Subject: Integrated Overflow Abatement Plan Modification
DOJ Case No. 90-5-1-1-08254

Integrated Overflow Abatement Plan Modifications

Subject: Southwestern Parkway Storage Basin
Minor Project Modification
IOAP Project No. L_OR_MF_105_M_13_B_A_0
DOJ Case No. 90-5-1-1-08254

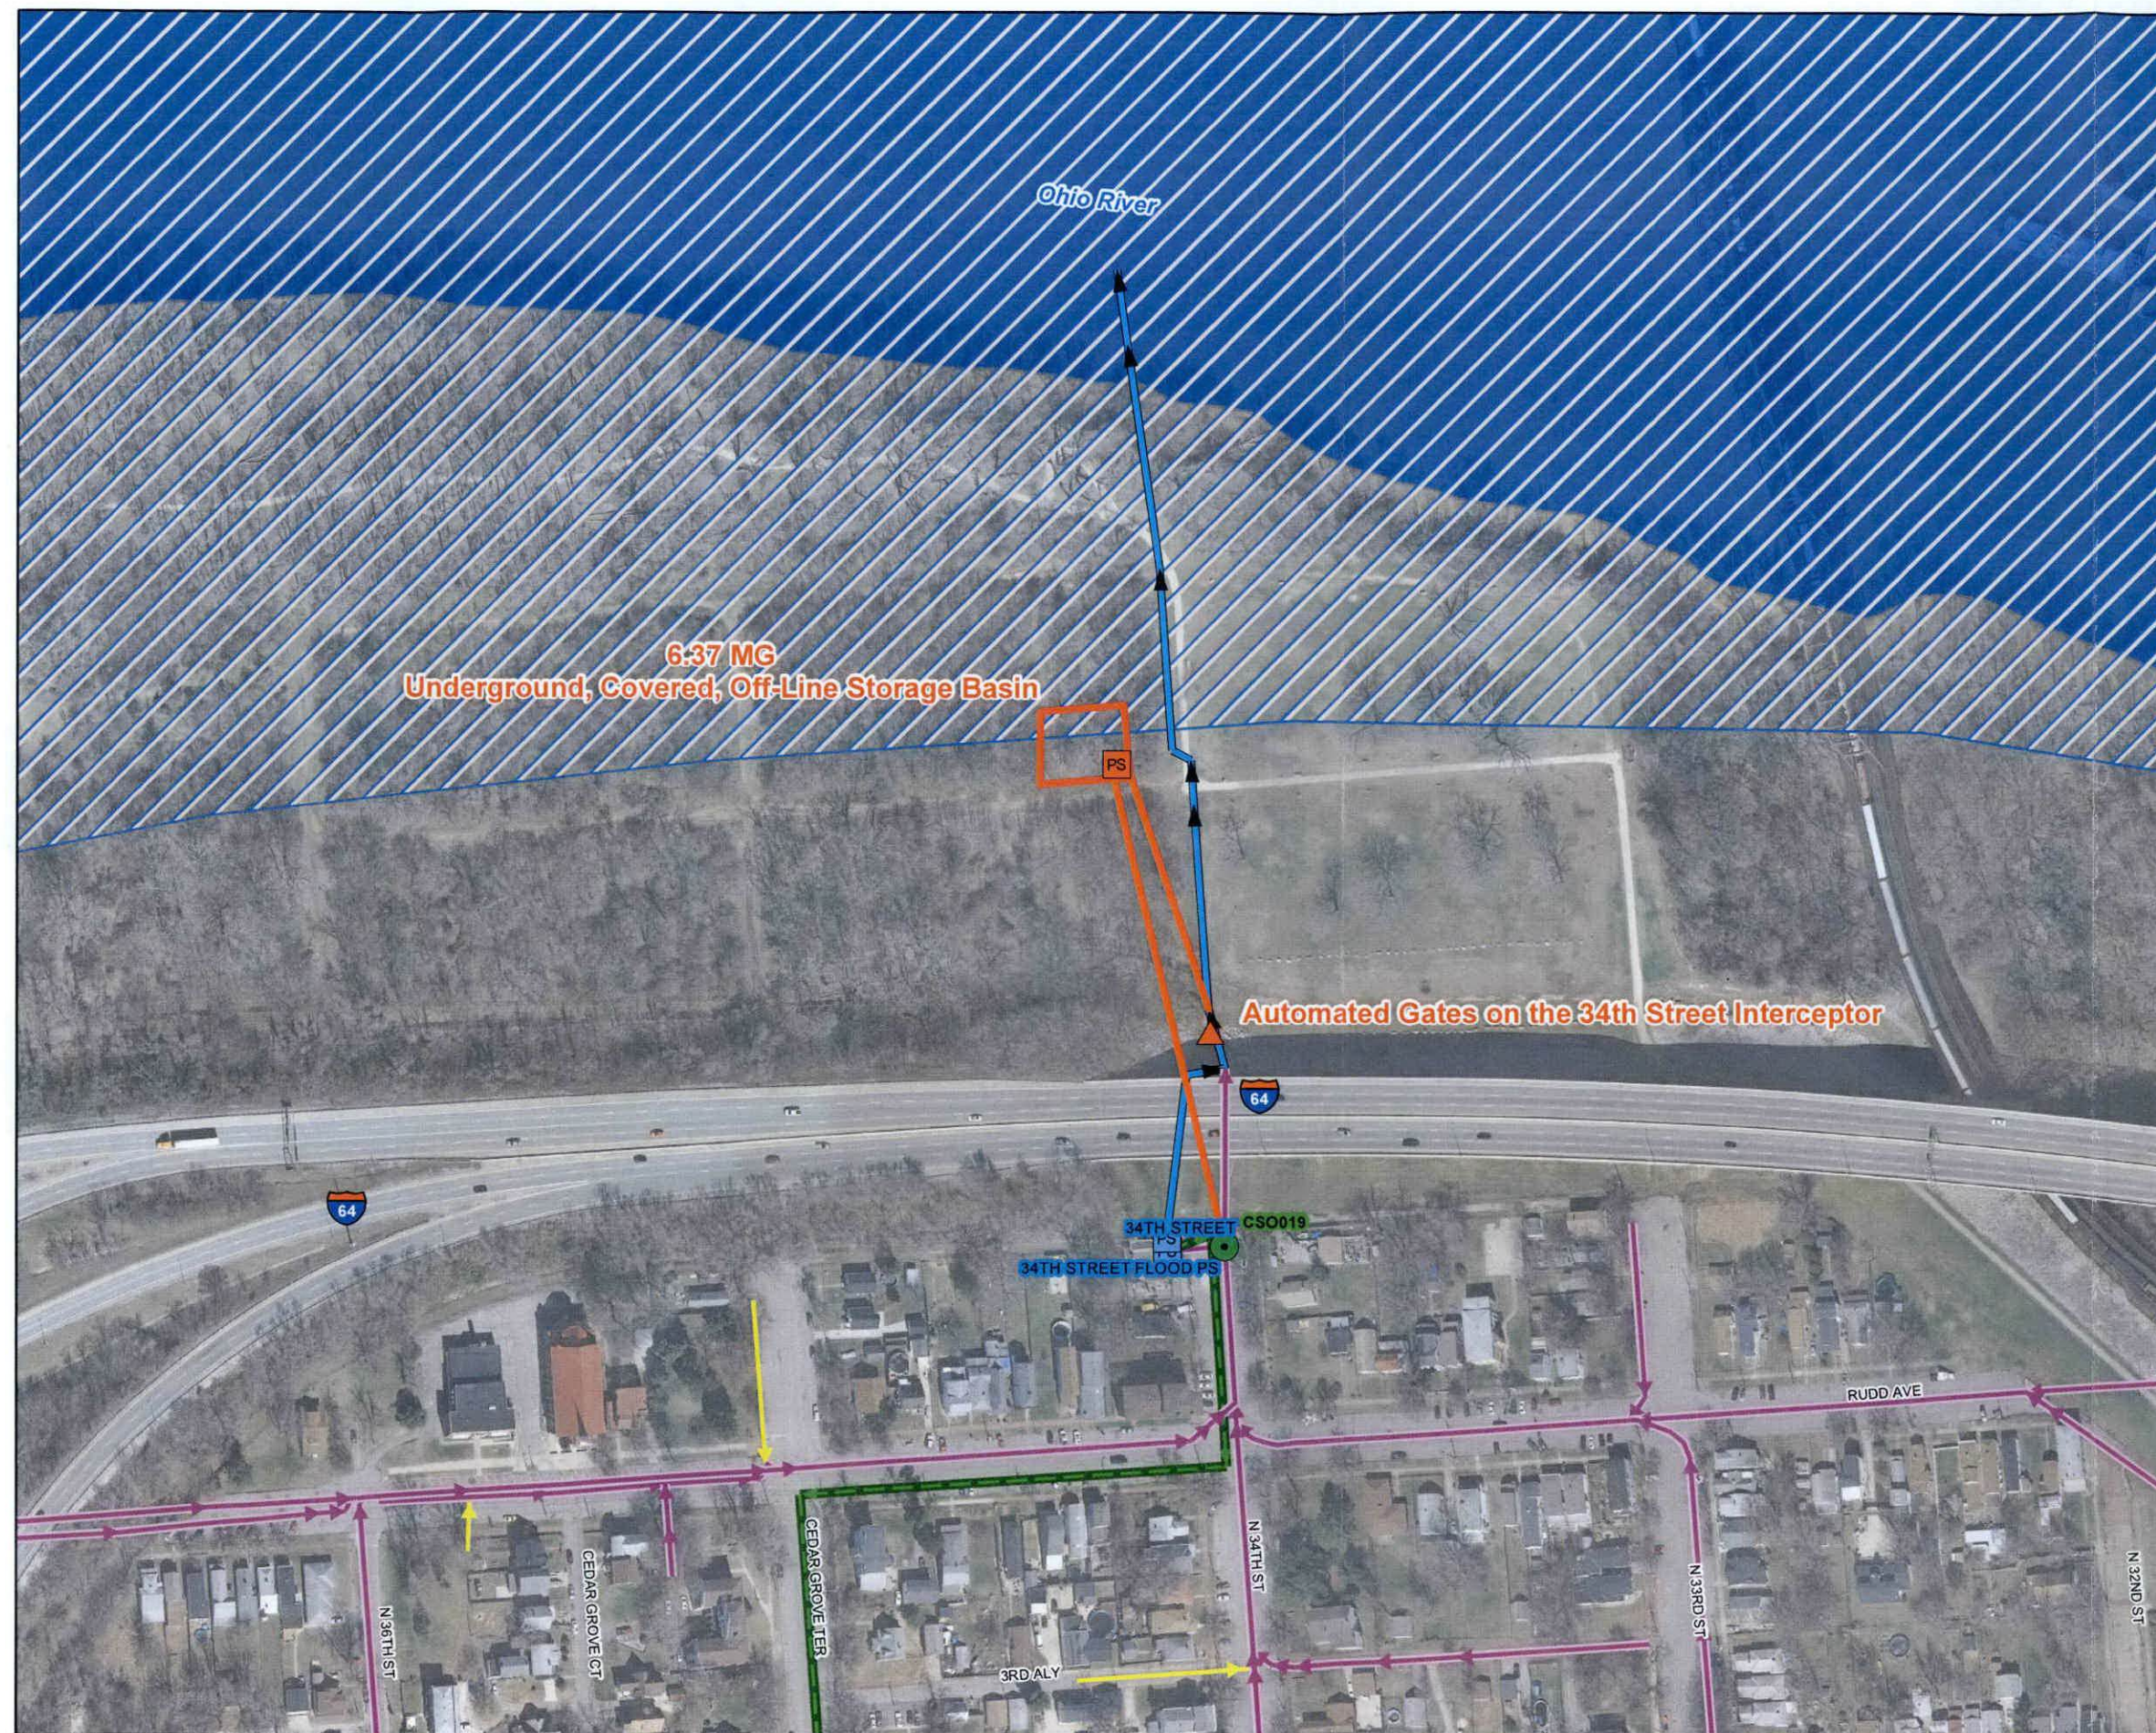
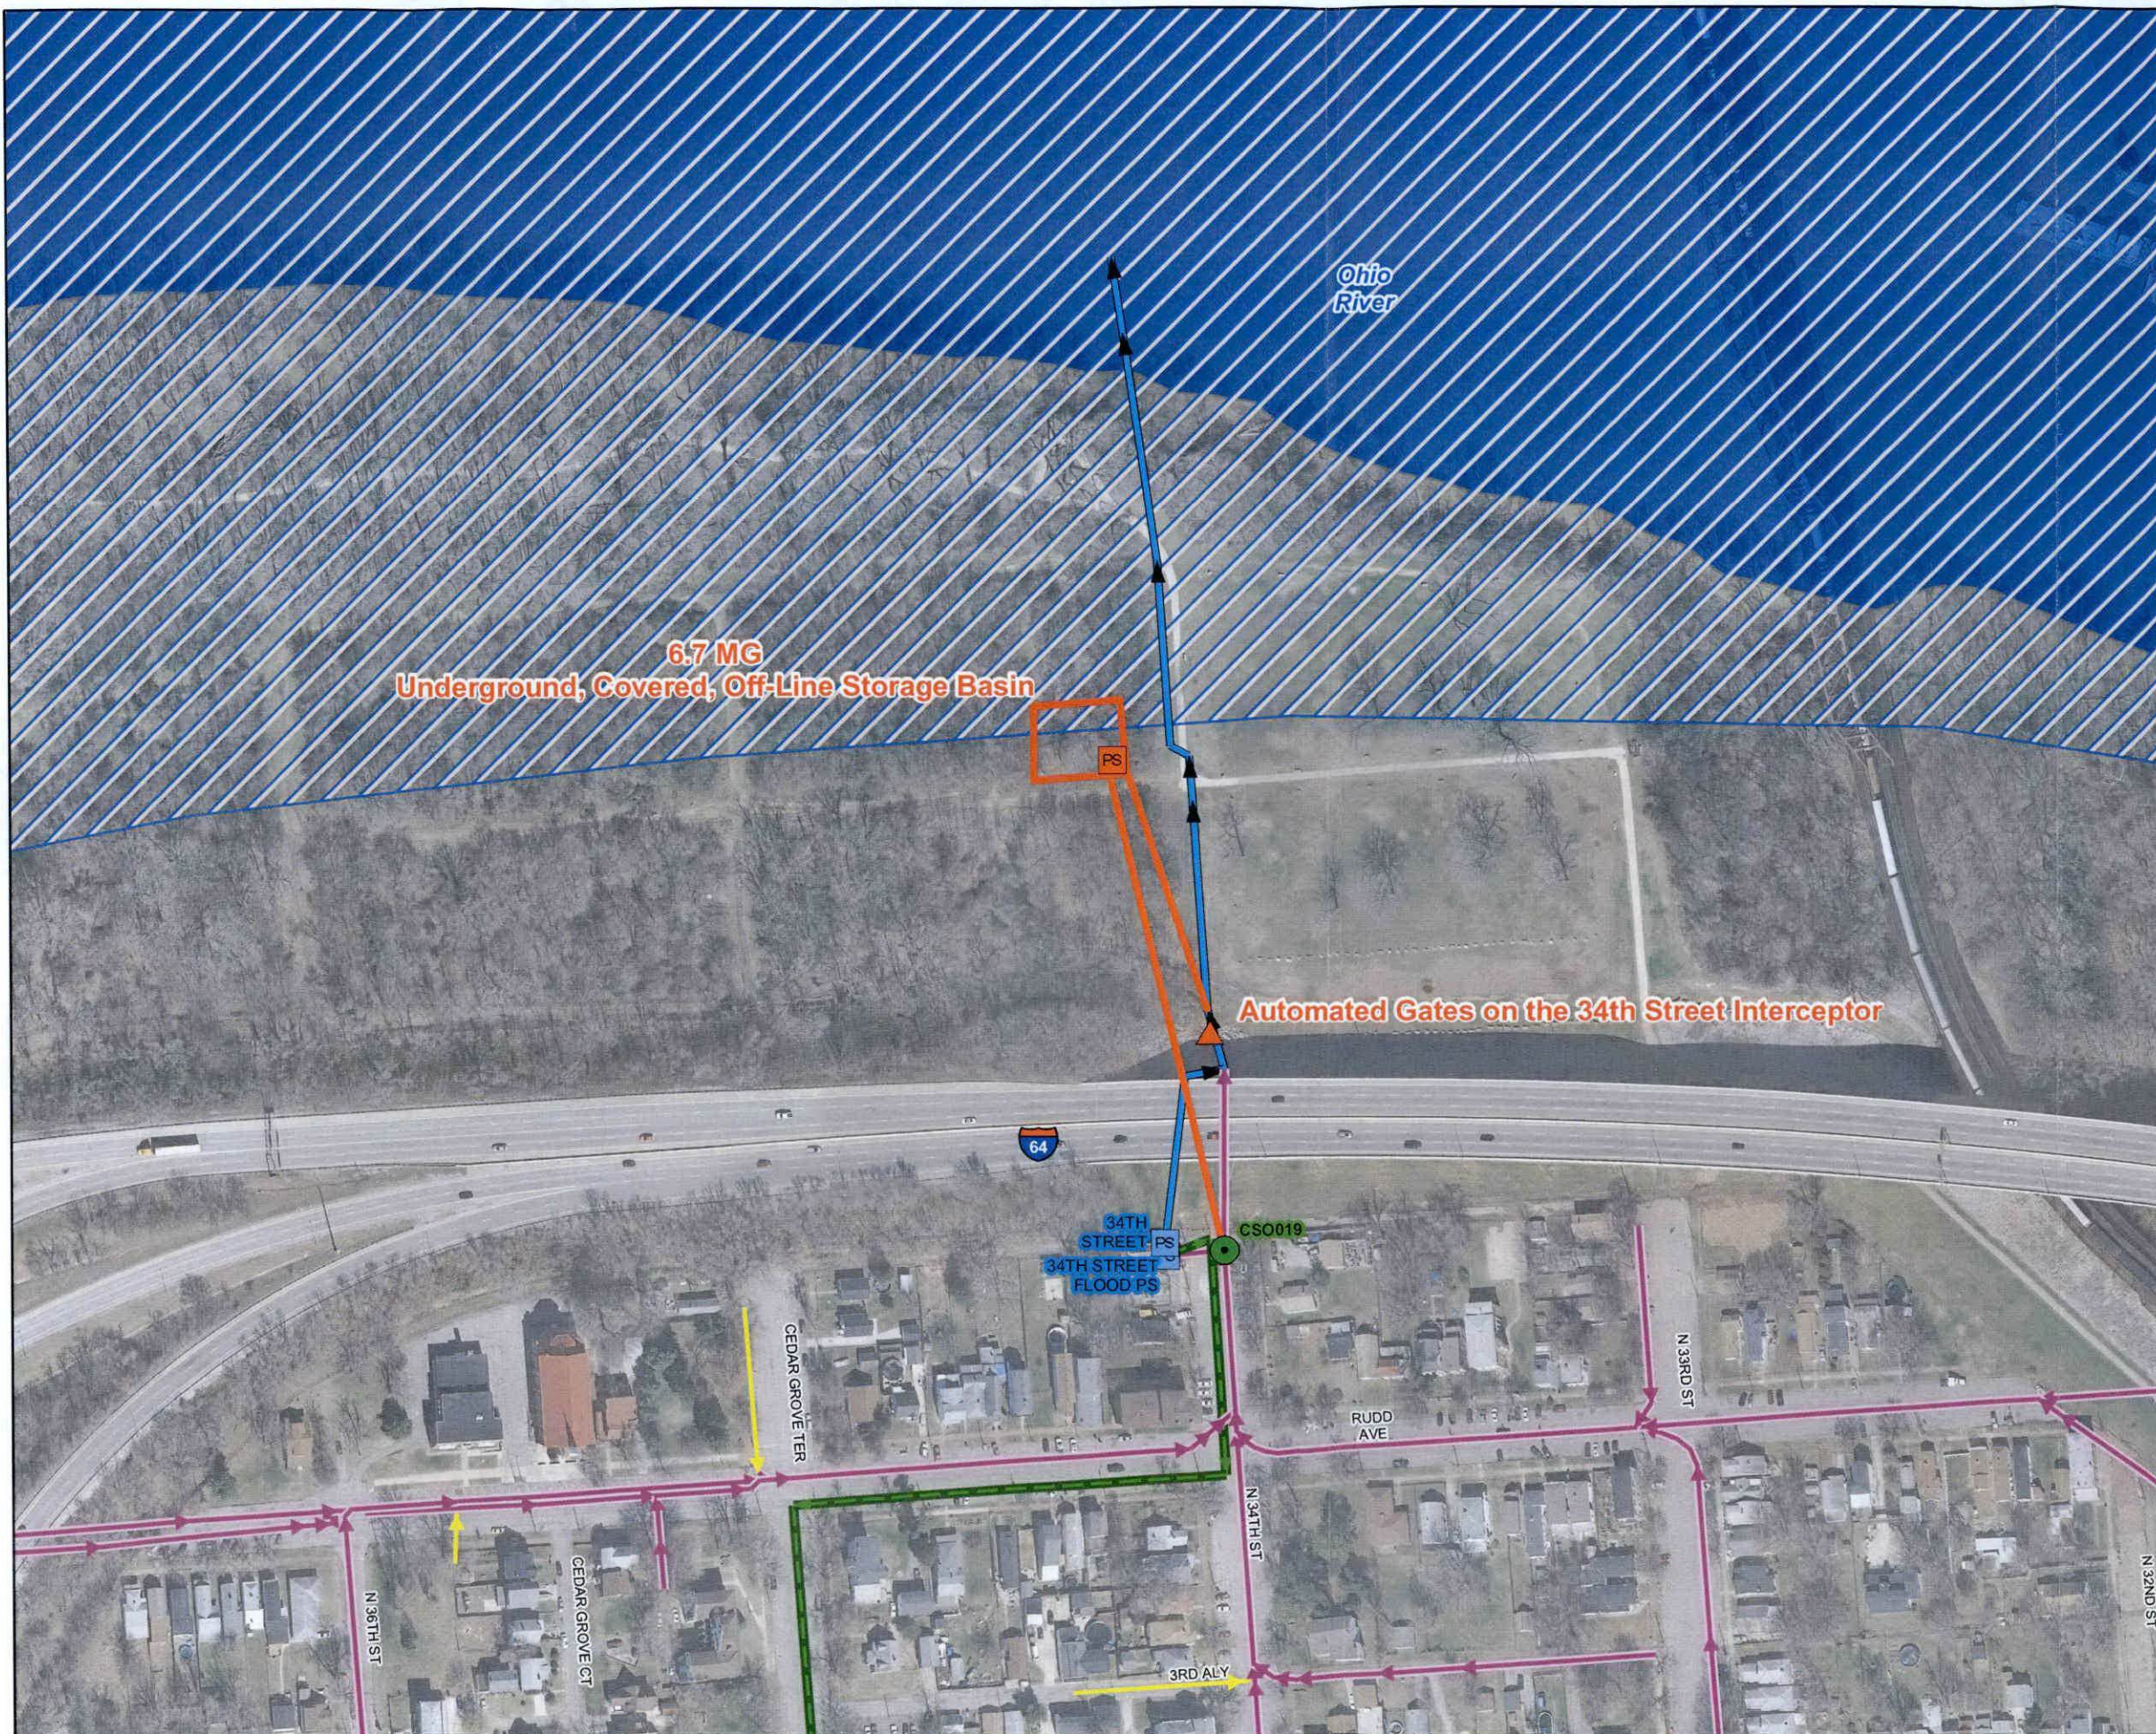
This project modification request includes increasing the Portland Wharf Storage Basin size from 6.37 MG to 6.7 MG. The level of control is proposed to remain at 8 overflows per year in the typical year. The larger size

does not reduce CSO occurrences significantly, but does provided a reduced residual AAOV. No change in project completion date is proposed.
